FIELD ORDER SUMMARY

Project: Saranac Lake Gas Co. Remedial Action	Project Location: Village of Saranac Lake, Essex County, New York
Client: NYSDEC	NYSDEC Site No.: 516008
Contractor: LAND Remediation, Inc.	MACTEC Project No.: 3611181219

FIELD ORDER

Project Name:	Saranac Lake Gas Company, Remedial Action	FO No.: 1
Project Location:	Village of Saranac Lake, Essex County, New York	Date Issued: 7/17/2018
		Site No.: 516008
Client:	New York State Department of Environmental Conservation (Department)	Contract No.: D010663
Contractor:	LAND Remediation, Inc.	Associated RFI or PCO: <input type="checkbox"/> RFI No. ___ <input checked="" type="checkbox"/> PCO No. 4 <input type="checkbox"/> None
MACTEC Project No.:	3611181219

If yes, describe: Figure 1 – Confirmation Sediment Sampling Plan

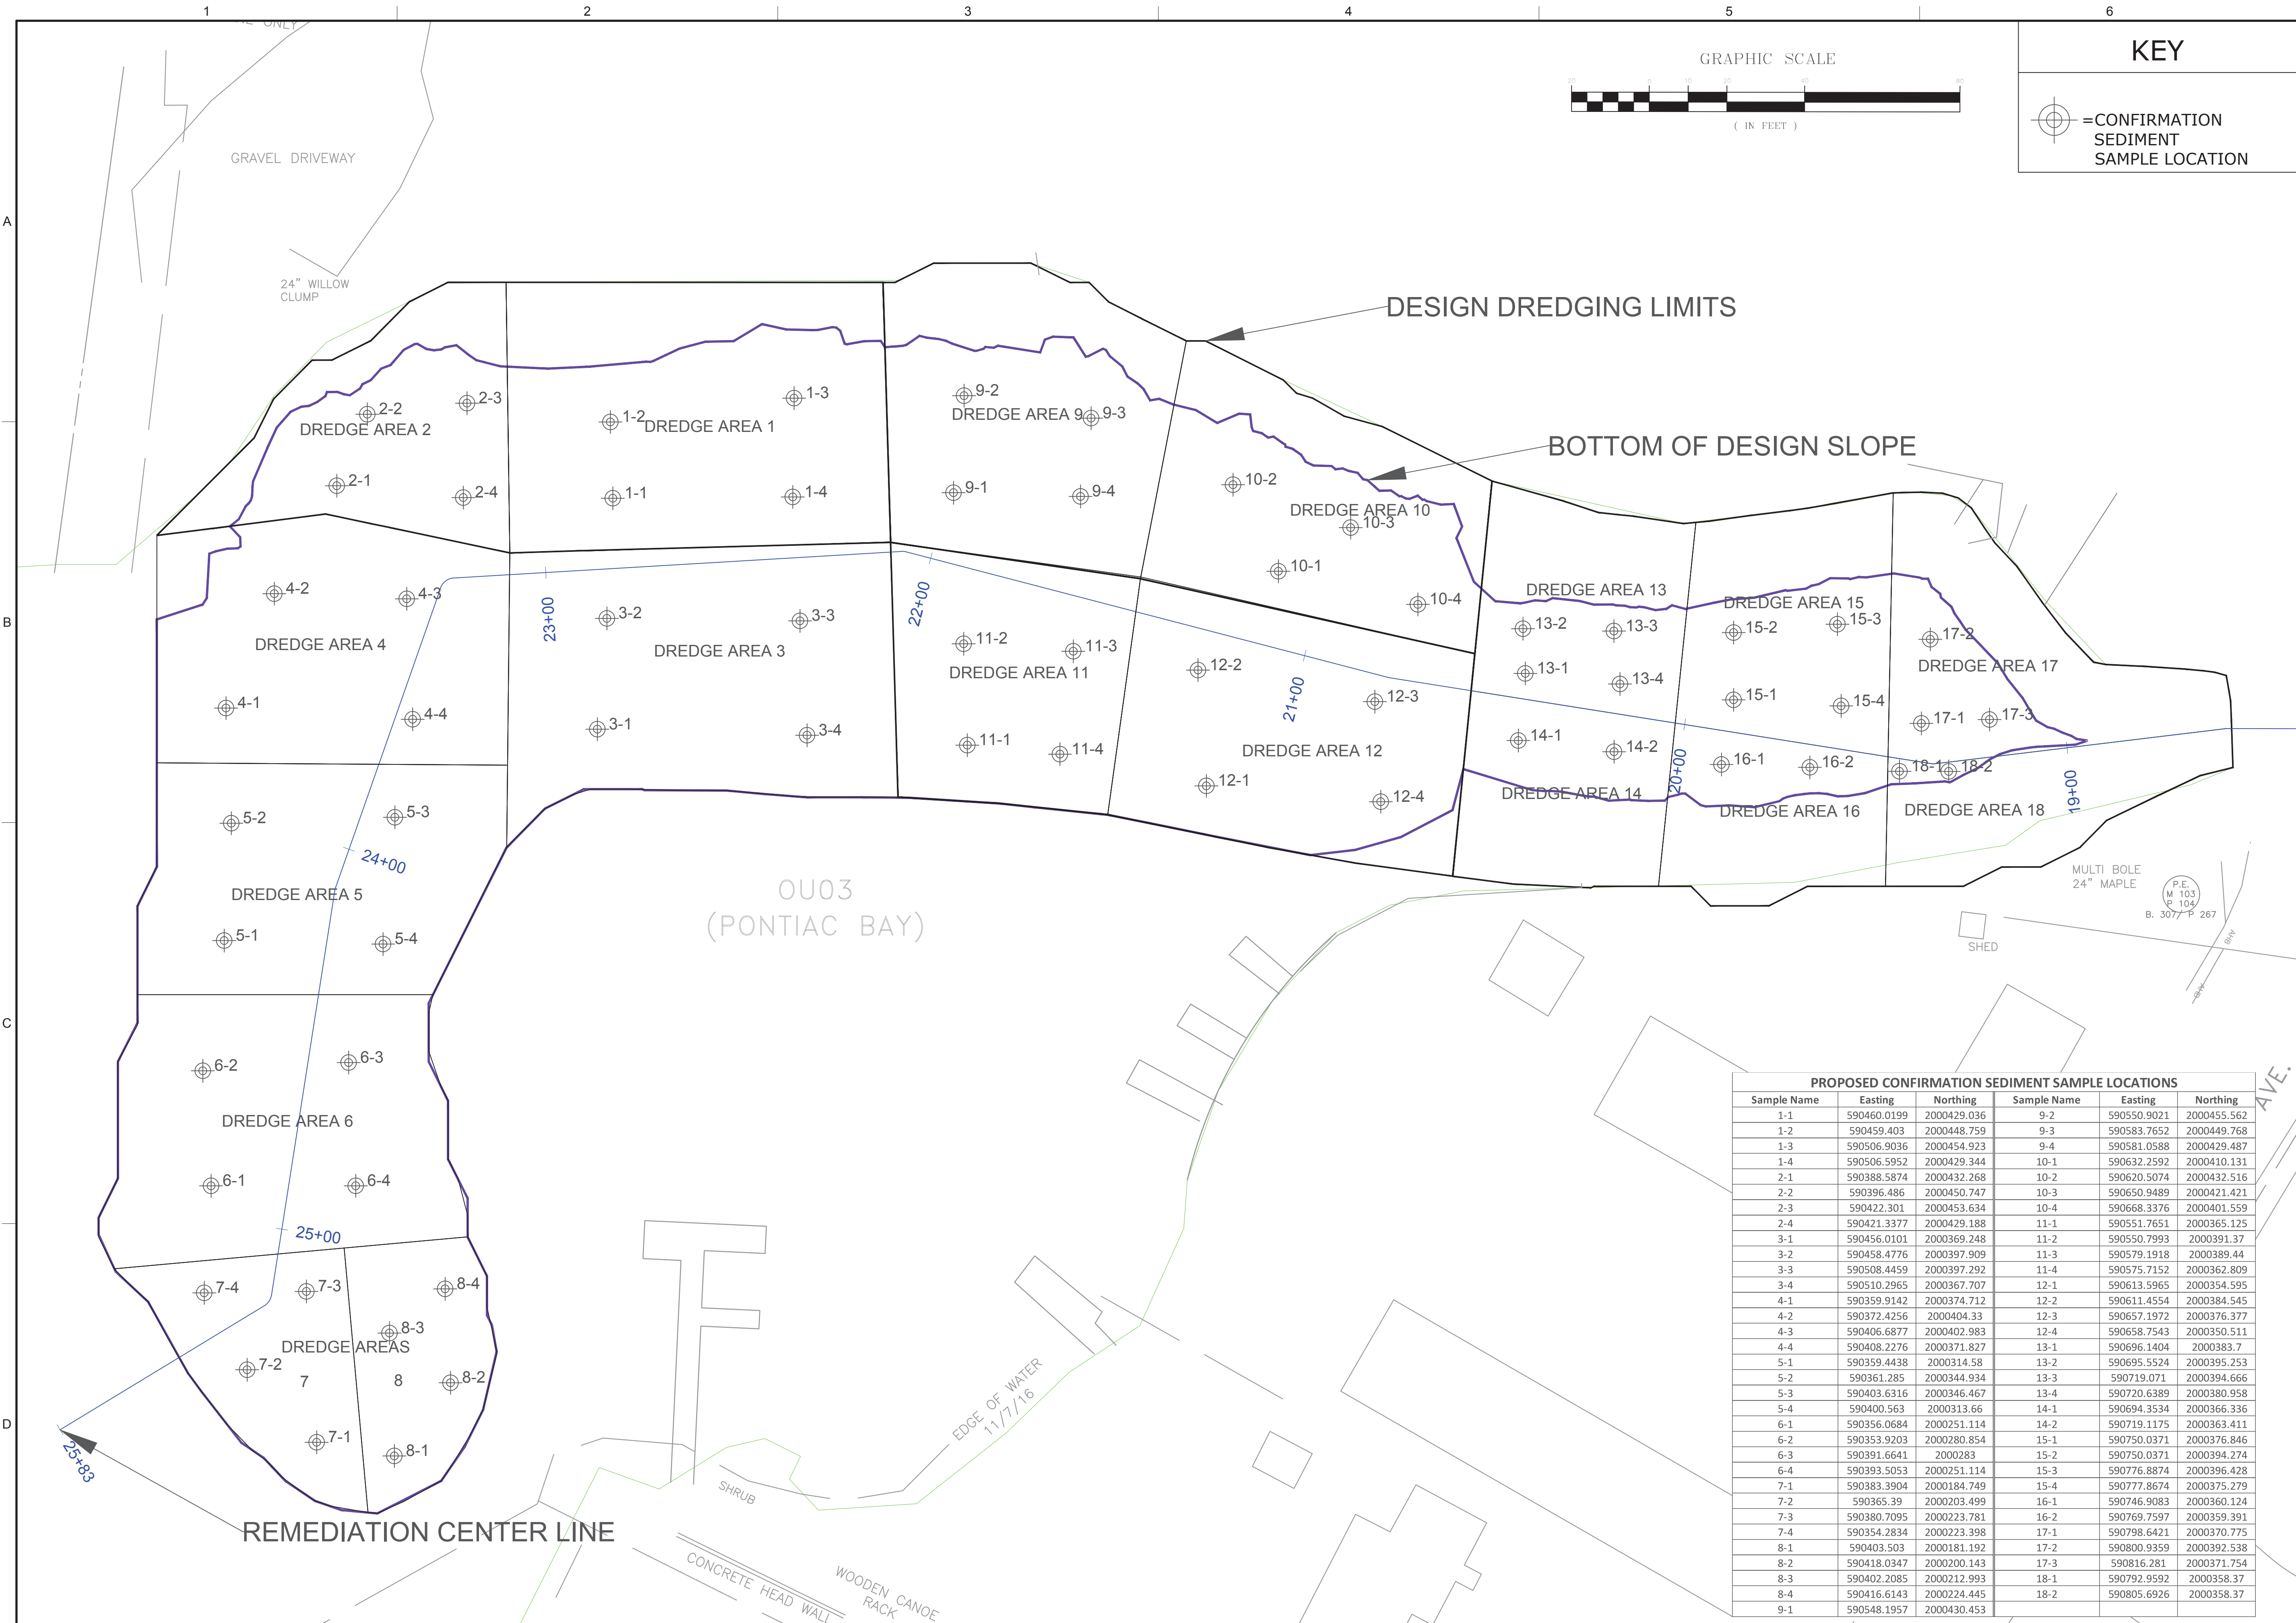
Post-confirmation samples shall be collected as specified in Section 01 45 28 of the contract specifications and consist of the collection of discrete samples from each of the 18 dredge areas as shown on Figure 1. Sediment from each discrete sample within each area of the 18 dredge areas shall be used to make a composite sample representing the respective dredge areas. The 18 composite samples and 65 discrete samples shall be sent to the approved laboratory. The laboratory shall analyze the 18 composite samples per Section 01 45 28 of the contract specifications and archive the 65 discrete samples pending review of the composite sample results. Composite sample analytical results will be compared to the applicable Sediment Cleanup Objectives for the Class A Sediment Criteria for the identified primary contaminants of concern (COC) for the Site. If cleanup objectives are not met based on the results of the composite sample for each of the 18 areas, the representative discrete samples for that area(s) shall be analyzed for the COC(s) that exceeded the acceptable limits.

BULKHEAD
RESTORATION

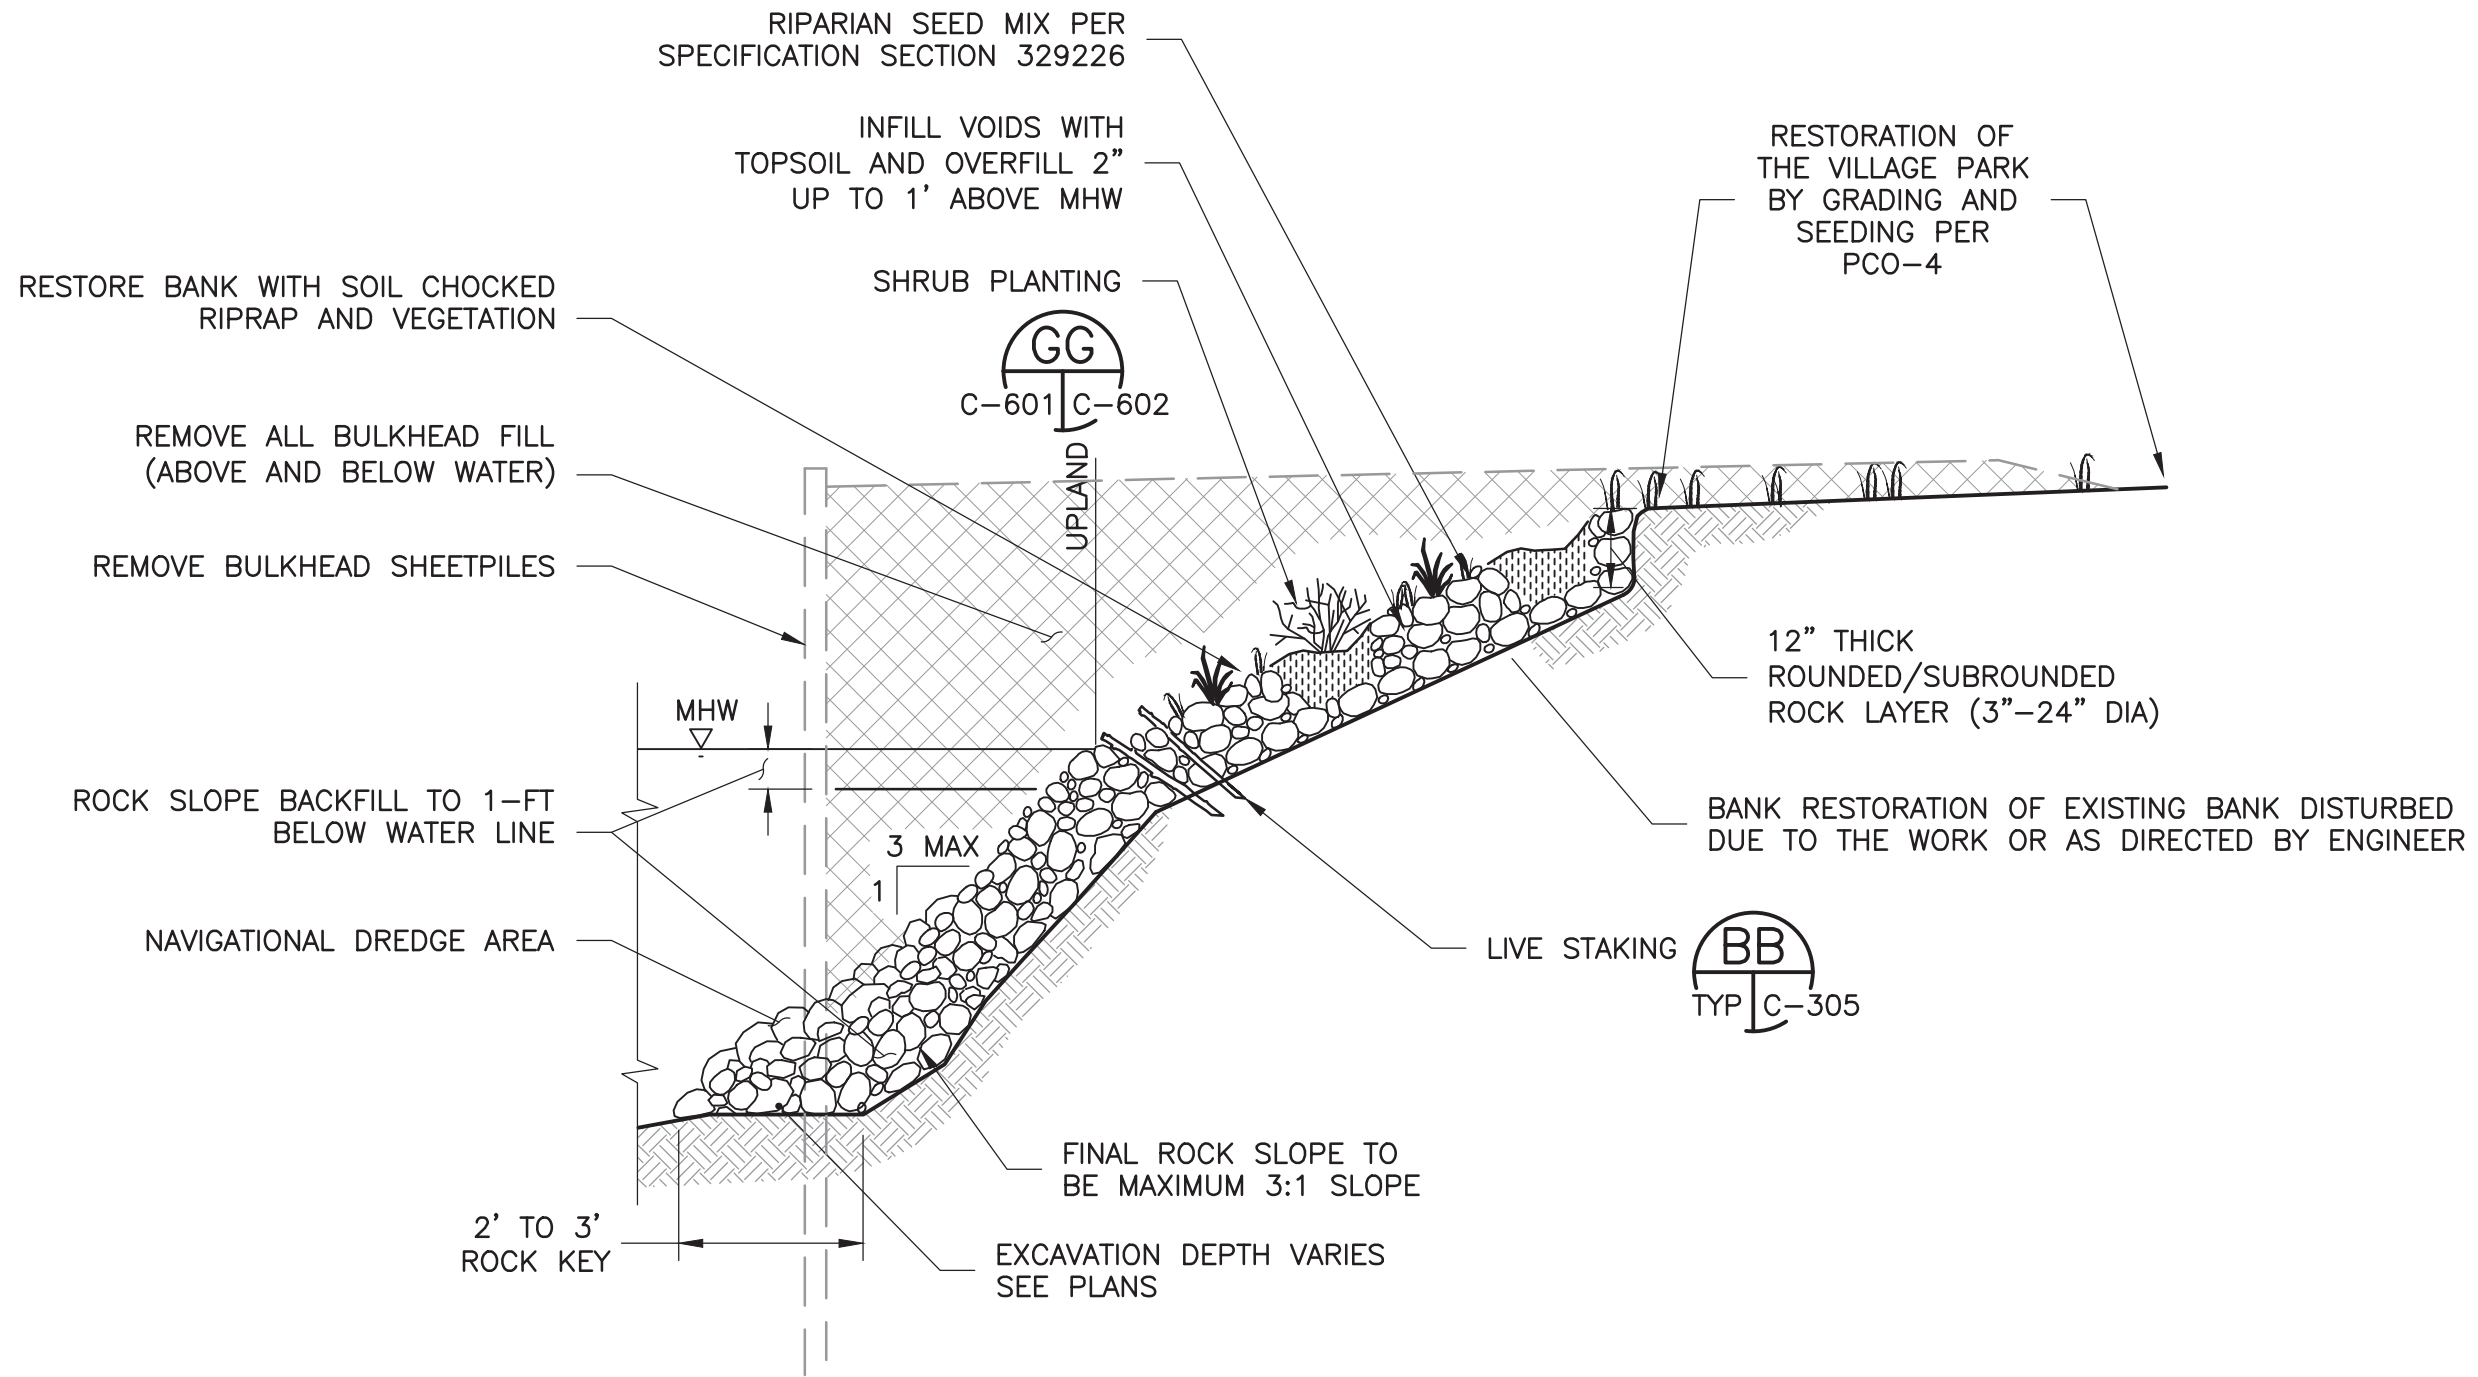
1. Remove all of the temporary bulkhead fill materials installed by LAND as part of the TFS design (both above and below the water) to pre-construction elevation. Fill material shall be characterized, removed, and disposed of in accordance with the Contract. Disposal of fill material as part of the TFS is covered under Bid Item 1.
2. Remove the bulkhead sheet piling and piles.
3. Place additional riprap backfill just below the water elevation down to the toe of the navigation dredged limits at a stable slope (3H:1V).
4. Complete shoreline restoration with the Soil Choked Riprap Detail AA-1 on Figure FO6-1.
5. Restore the upland area above soil choked rip rap by grading and seeding per PCO 4.

The location of the barge pier bulkhead is located within the remediation limits impacted by the sediment dredge work and has been restored. The restoration of the upland area above soil choked rip rap shall be graded and seeded per PCO 4.
